# AEROPRAKT SERVICE BULLETIN

No. SB A32-02

# MODIFICATION OF ALL-MOVING HORIZONTAL TAIL (AMHT) OF A32 AND A32L AIRCRAFT

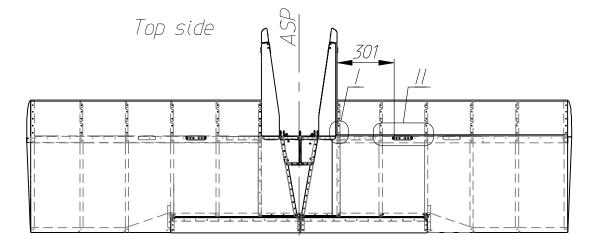
Inspect the AMHT in the area of mod kit parts installation (see detail views II and IV in fig. 1 and 2) for dents, deformation and cracks. If any damage is found in the above mentioned areas consult the manufacturer.

Bottom side 569

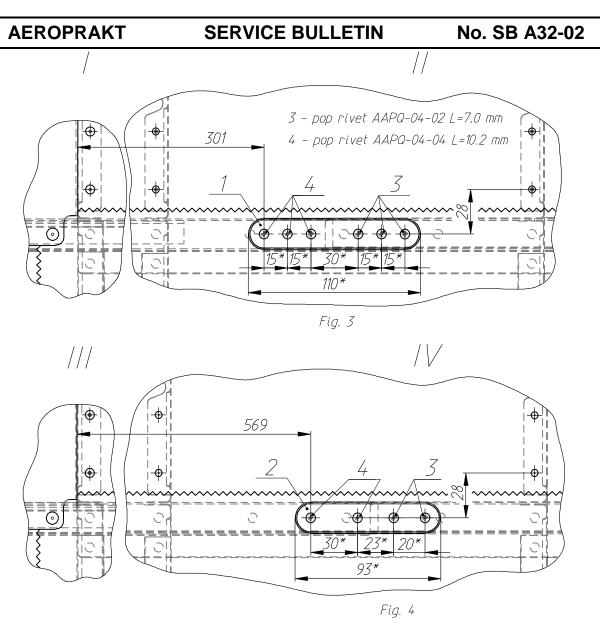
- Fig. 2
- 1. Installation of the top (righthand and lefthand) doublers:
- 1.1. Mark 2 holes (1 per righthand/lefthand side) on the top side of the AMHT at 301 mm distance as shown in fig. 1 and 3.
- 1.2. Drill the 2 marked holes with  $\emptyset$ 3.3 mm drill bit.
- 1.3. Install the doublers (1) on Cleco fasteners symmetrically about the aircraft symmetry plane (ASP).
- 1.4. Using the holes in the doublers as pilot holes drill  $\emptyset$ 3.3 mm holes 5 holes on each (righthand/lefthand) side.
- 1.5. Remove the doublers, deburr/blunt the sharp edges of the holes, remove the metal chips.
- 1.6. Attach the doublers with pop-rivets (3) and (4) as shown in fig. 3 (symmetrically about the ASP).

- 2. Installation of the bottom (righthand and lefthand) doublers:
- 2.1. Mark 2 holes (1 per righthand/lefthand side) on the bottom side of the AMHT at 569 mm distance as shown in fig 4.
- 2.2. Drill the 2 marked holes with  $\emptyset$ 3.3 mm drill bit.
- 2.3. Install the doublers (2) on Cleco fasteners symmetrically about the ASP.
- 2.4. Using the holes in the doublers as pilot holes drill  $\emptyset$ 3.3 mm holes 3 holes each (righthand/lefthand) side.
- 2.5. Remove the doublers, deburr/blunt the sharp edges of the holes, remove the metal chips.
- 2.6. Attach the doublers with pop-rivets (3) and (4) as shown in fig. 3 (symmetrically about the ASP).
